UNITED STATES PATENT AND TRADEMARK OFFICE

APPLICATION NO.	FILING DATE	FIRST NAMED INVENTOR	ATTORNEY DOCKET NO.	CONFIRMATION NO.
10/581,325	06/01/2006	Dieter Hagist	502901-348PUS	3578

Office Action Summary	Application No. 10/581,325	Applicant(s) HAGIST ET AL.	
	Examiner AMENE S. BAYOU	Art Unit 3746

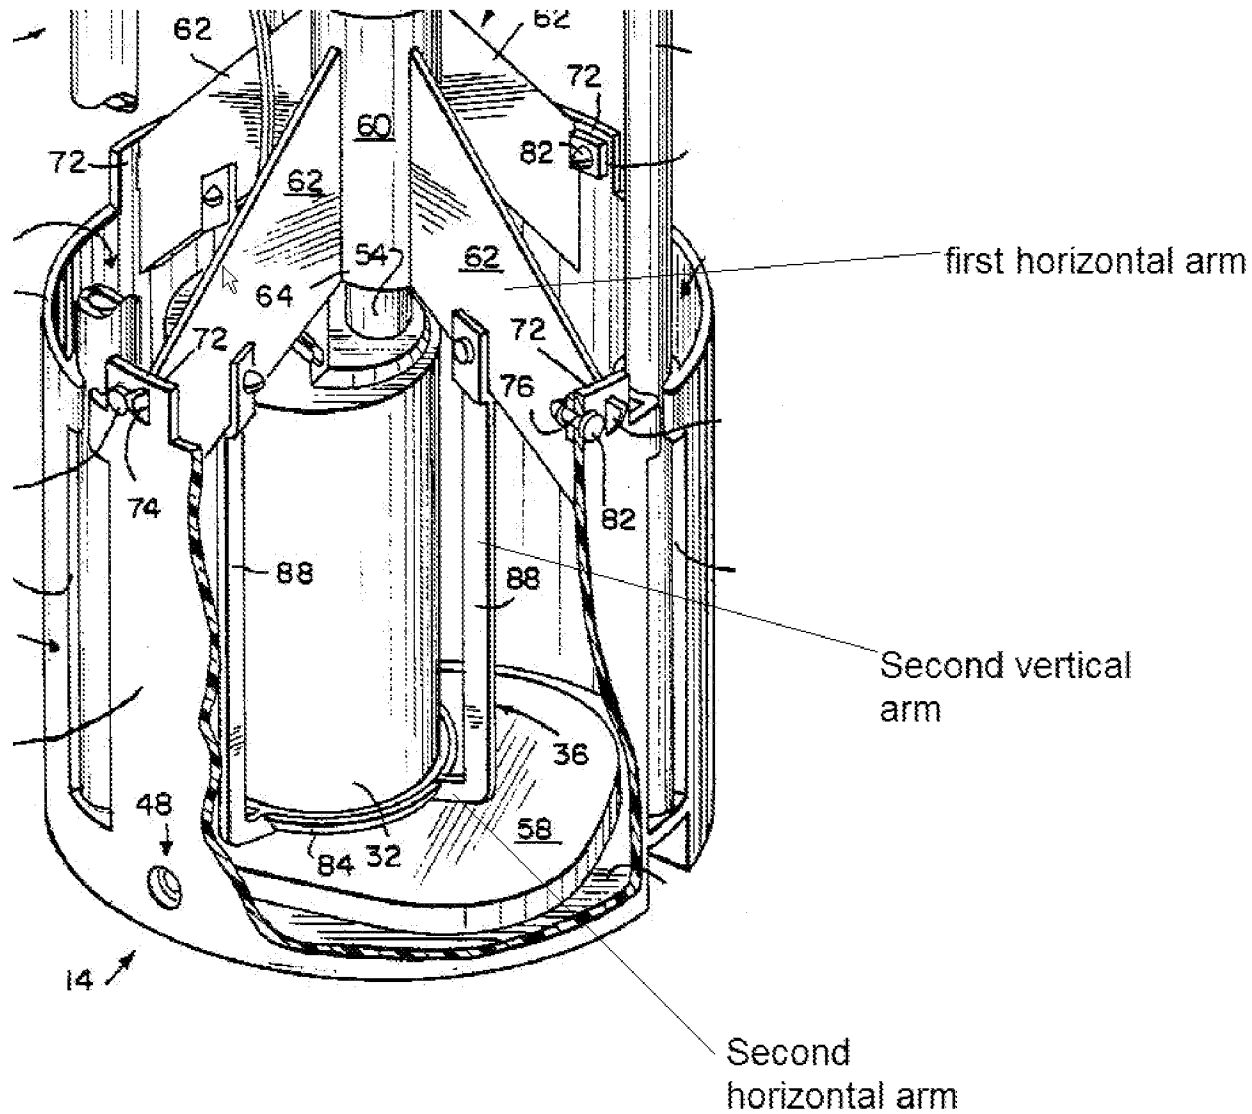
Harris teaches a device for retaining a fuel pump in a fuel container of a motor vehicle (see figure 1), with a pump holder (including fin members (62) and legs (88)), with first retaining means of the pump holder (the fins (62)), provided for supporting on a baffle pot (the fins are supported on a reservoir cup (30)), and with second retaining means of the pump holder (pump carrier dish(84)), provided for supporting the fuel pump, and with a damping device (the legs (88)) connecting the first and the second retaining means to one another, in that the damping device has arms which are angled away from each other (the legs (88) have a vertical portion and a horizontal portion that is arranged at 90° to the vertical portion. In addition item 62 which is attached to the

horizontal portion of vertical legs 88 can be considered as a horizontal arm), and in that during a movement of the fuel pump the arms are subject to at least a torsional or a bending load (the arms would be subject to any stresses applied to the fuel pump and fuel tank, which includes bending and torsional loads), wherein the arms of the damping device include at least one first vertical arm extending substantially in a vertical direction and first and second horizontal arms extending substantially horizontally and angled away from the first vertical arm (the legs (88) have a vertical portion and a horizontal portion that is arranged at 90° to the vertical portion), the first and second horizontal arms being spaced apart in the vertical direction, and at least one of the first and the second horizontal arms is designed as an annular element (the vertical arms are arranged annularly around the fuel pump), wherein a second vertical arm (one of the vertical arms 88 can be considered second vertical arm) connects the first horizontal arm and the second horizontal arm of the damping device (see annotated drawing), and wherein only the second horizontal arm of the arms of the damping device is directly connected to the second retaining means (see annotated drawing again).

13. Applicant's arguments with respect to the rejection of claims 1-20 over Frank have been considered and found persuasive. Therefore the rejection is withdrawn. However applicant's argument with respect to the rejection of claim 1-20 over Harris (see page 4 paragraphs 2 and 3) is not found persuasive. Applicant argued that the legs 88 of Harris are disposed in the same horizontal plane and are not spaced apart in the vertical direction. Examiner notes that there is some confusion by the applicant in labeling the vertical legs and the horizontal portion of the legs (i.e. the arms) as being the same (see annotated drawing above for clarification). As clearly be seen in the drawing the

horizontal arms of the vertical legs 88 **are spaced apart in vertical direction and are not located on the same horizontal plane.**
